ADDENDUM NO. 2

Whiteland Community High School Phase 2A
300 E. Main Street
Whiteland, IN 46184

PROJECT: Whiteland Community High School Phase 2a

DATE OF ADDENDUM: May 2, 2024

JOB NO. _____ DRAWN: KLF CHECKED: TEN
DATE: APRIL 02, 2024 DESIGNED: DMS APPR: GJJ
SHEET 601

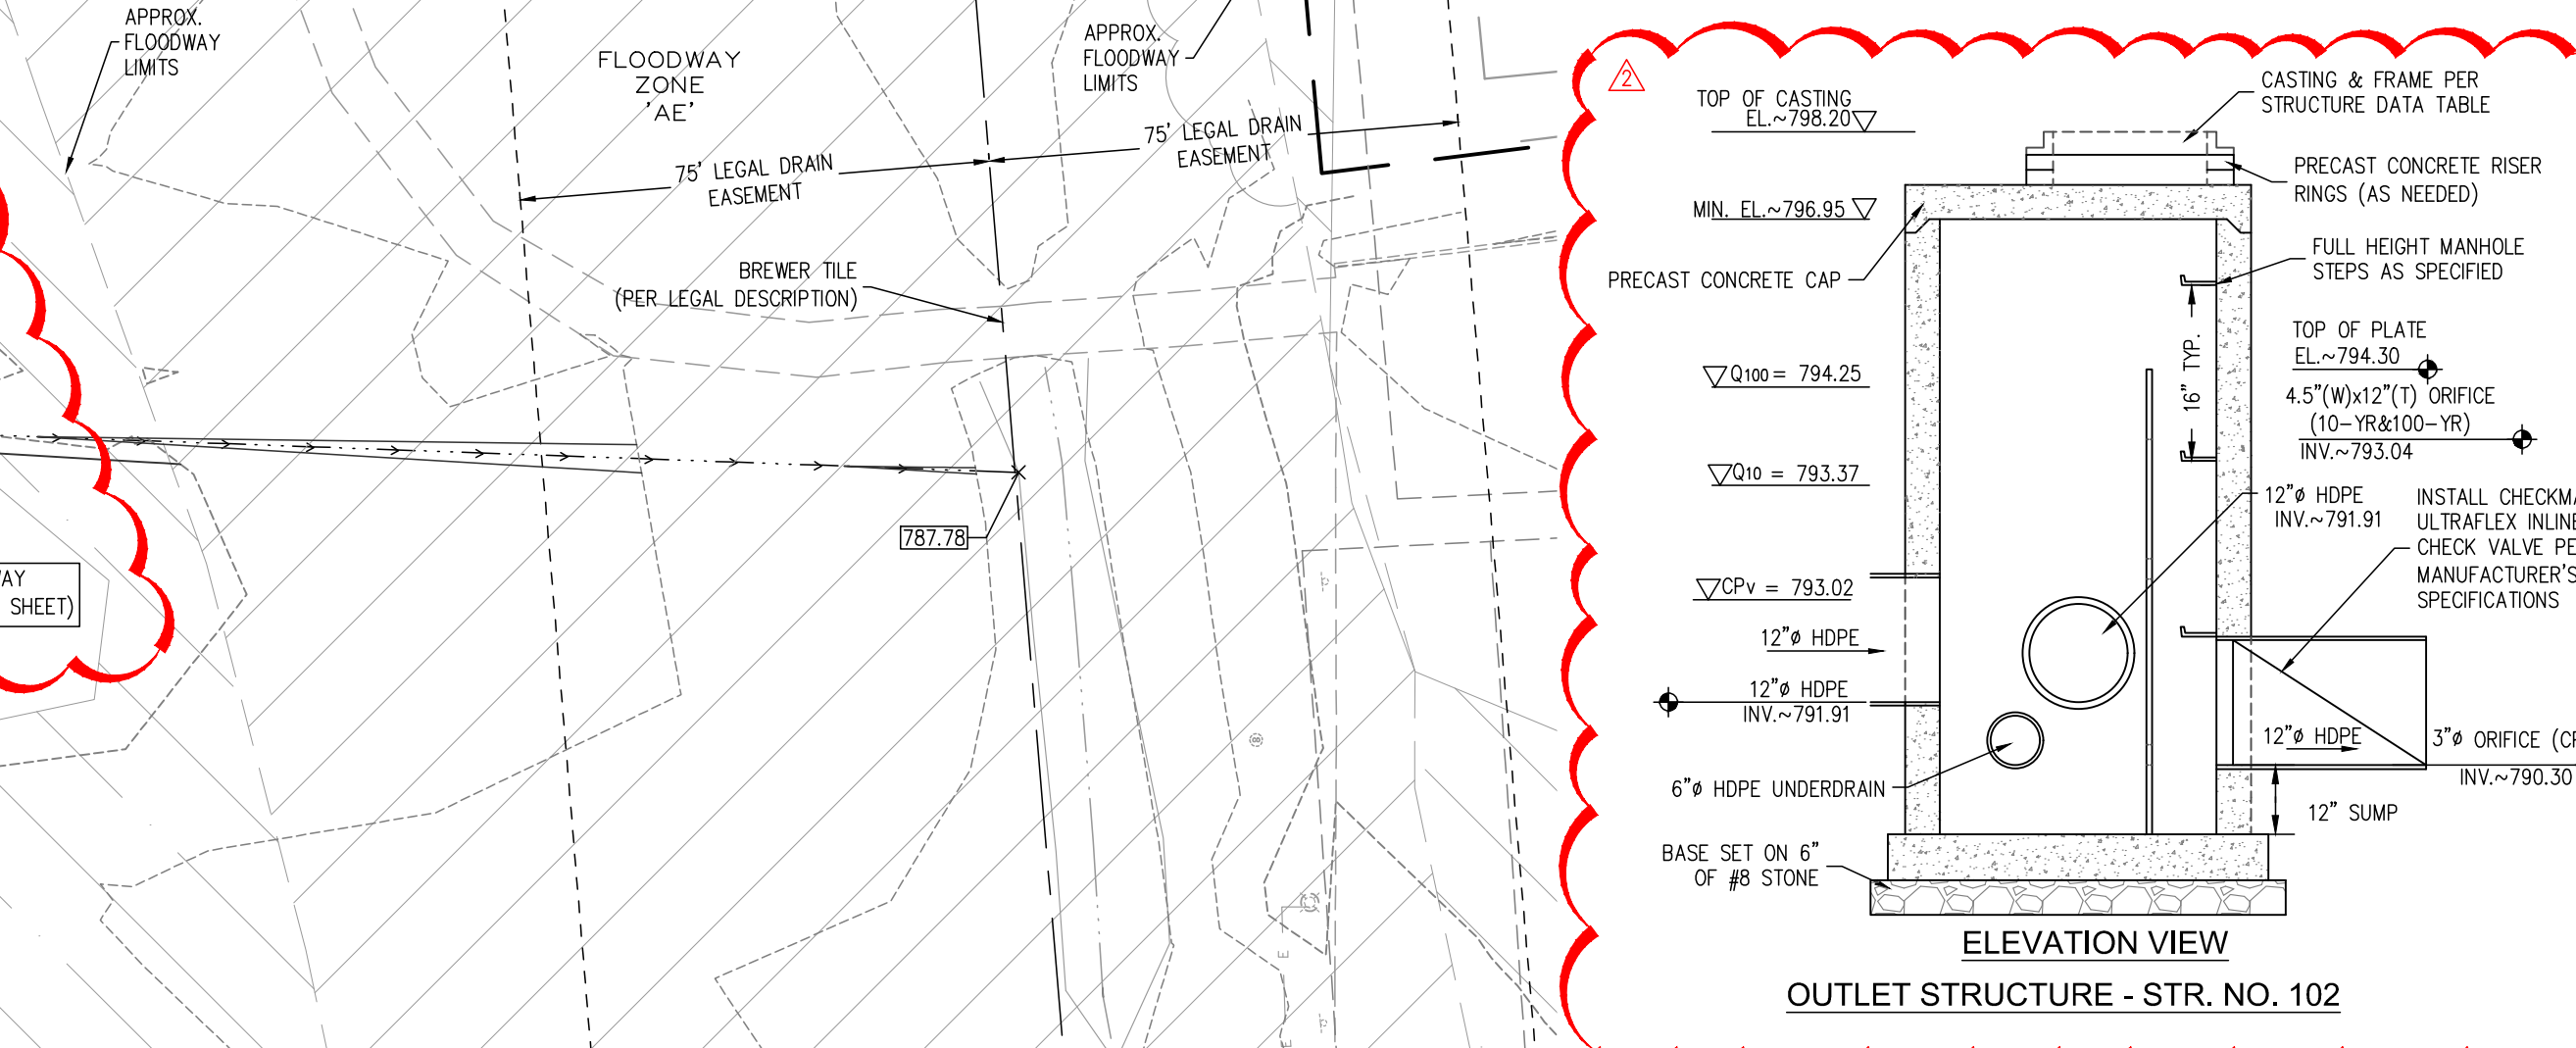
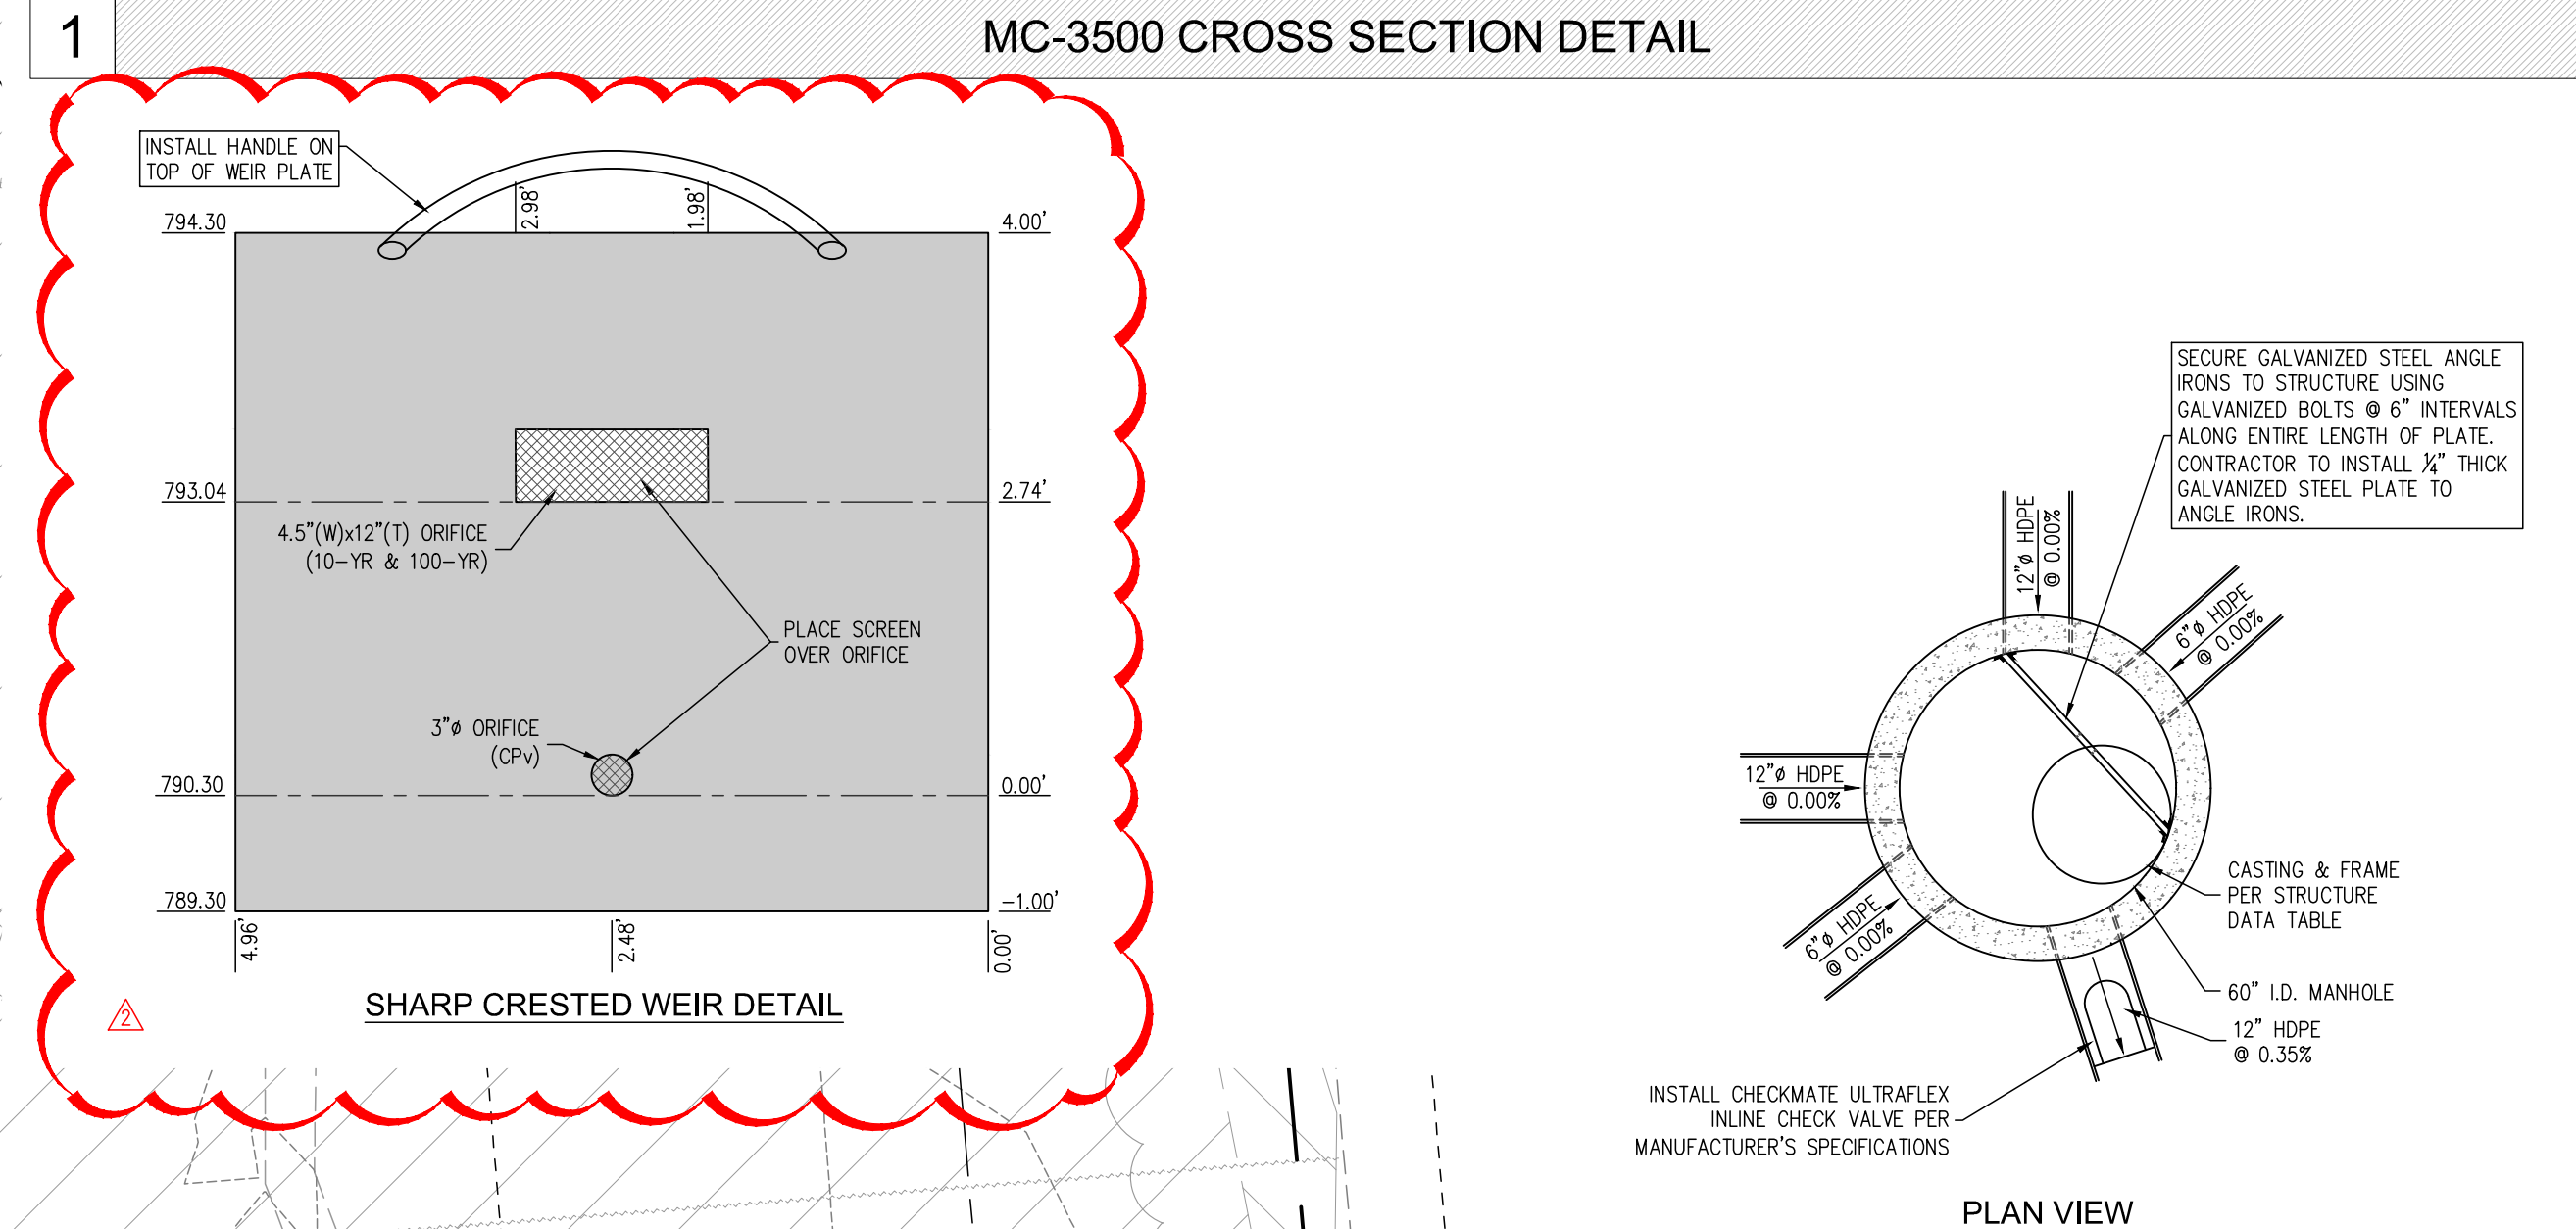
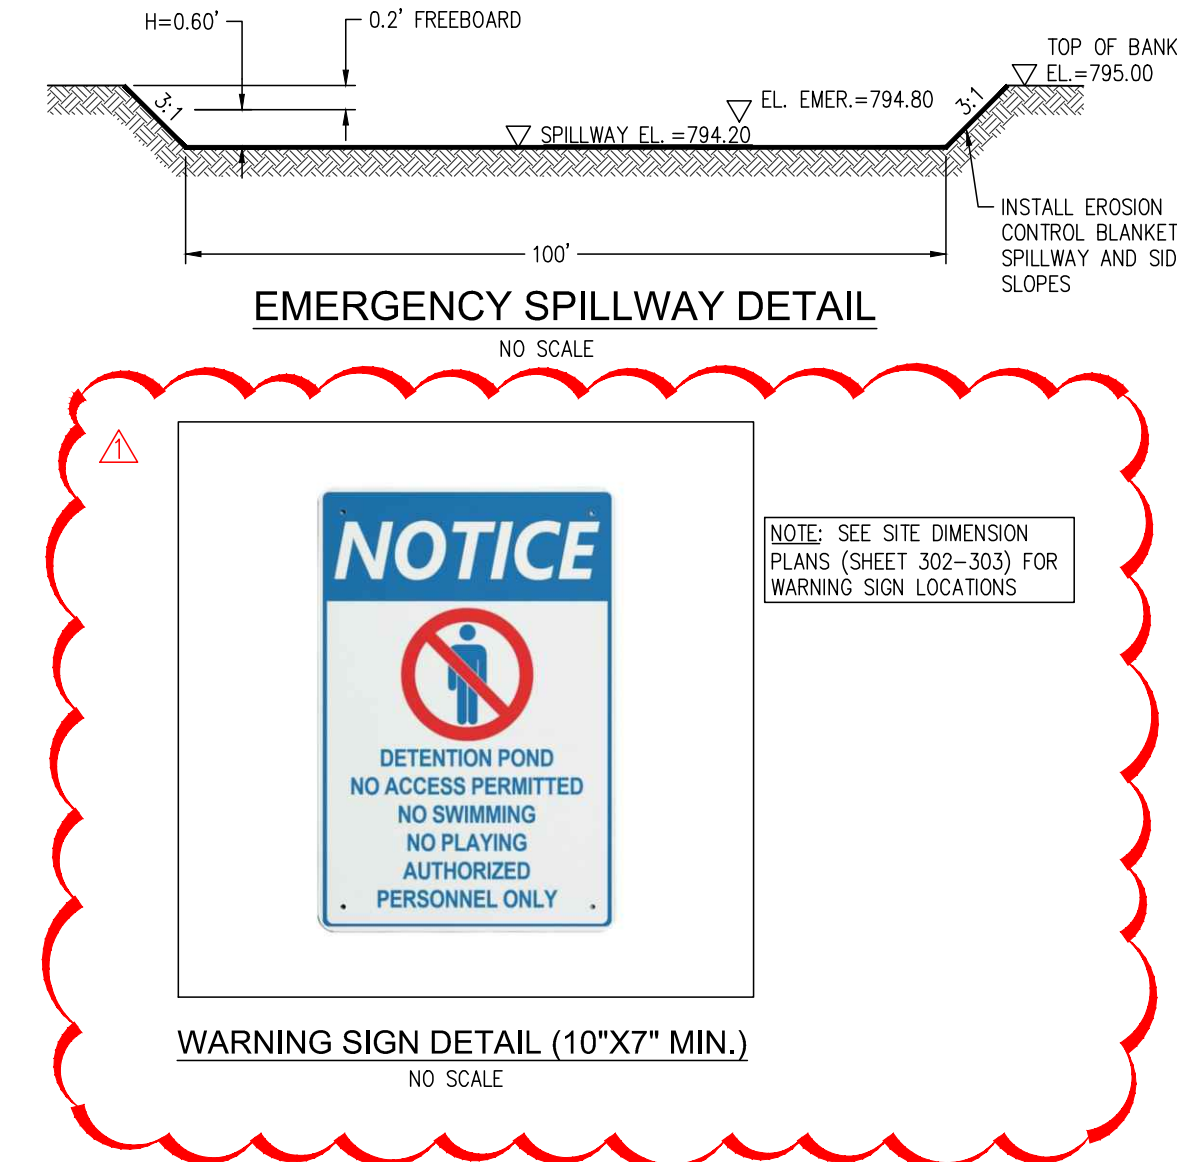
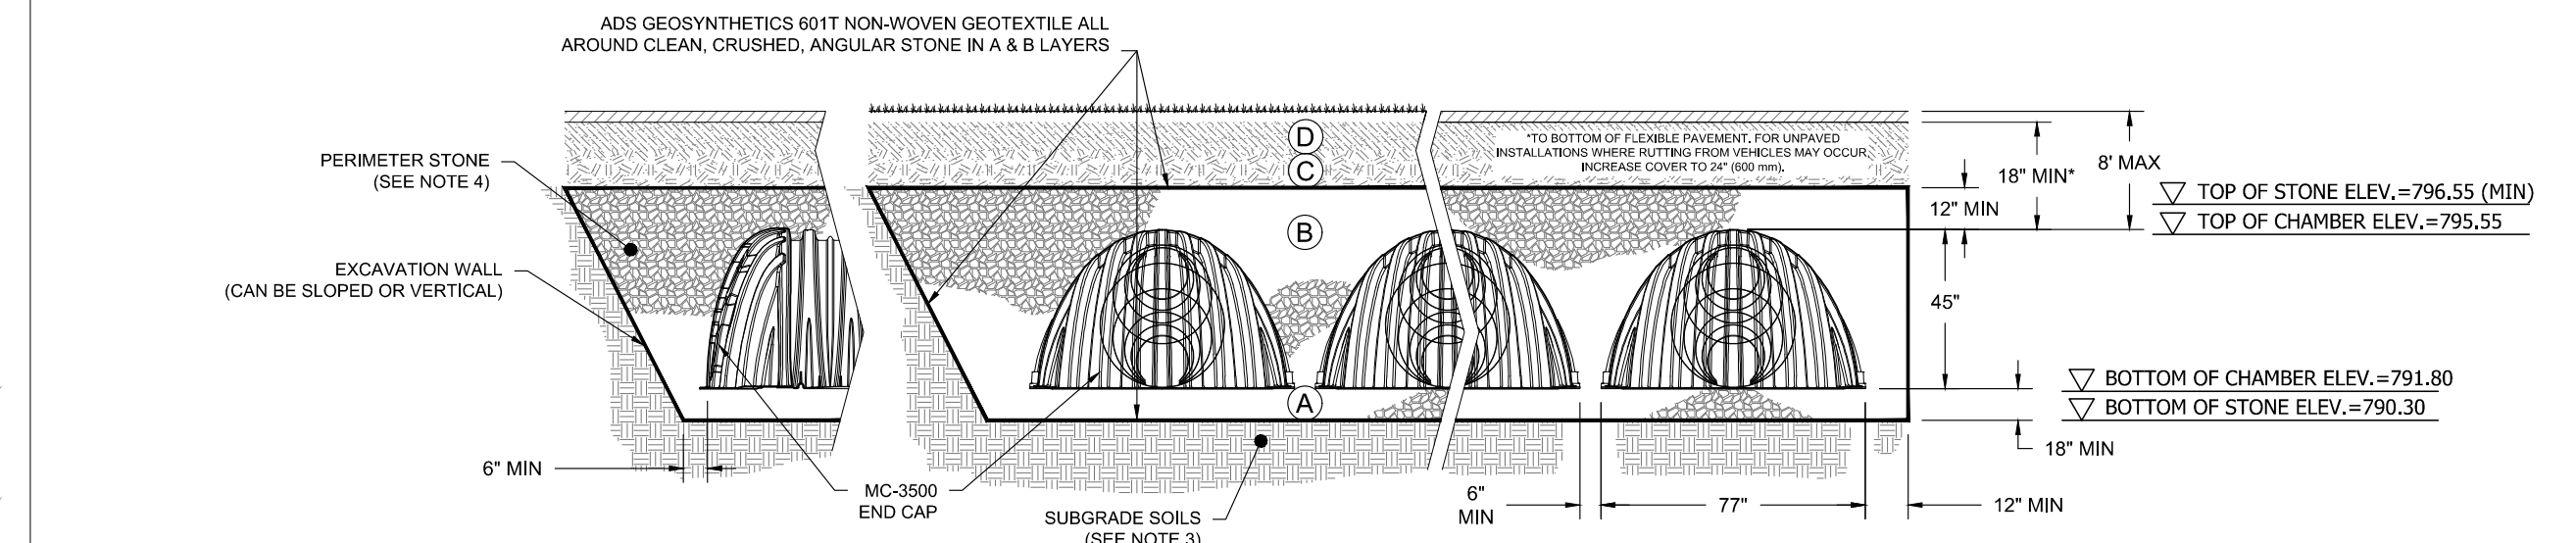
11 Drainage Plan (sheet 601):

- o Revised emergency spillway spot elevations in plan view to match detail.
- o Revised the underground detention and dry detention basin 10-yr and 100-yr water surface elevations to match the revised stormwater calculations.
- o Minor revisions to elevations shown on the outlet control structure detail for Str. No. 102.
- o Revised the sharp crested weir detail to match the revised stormwater calculations.
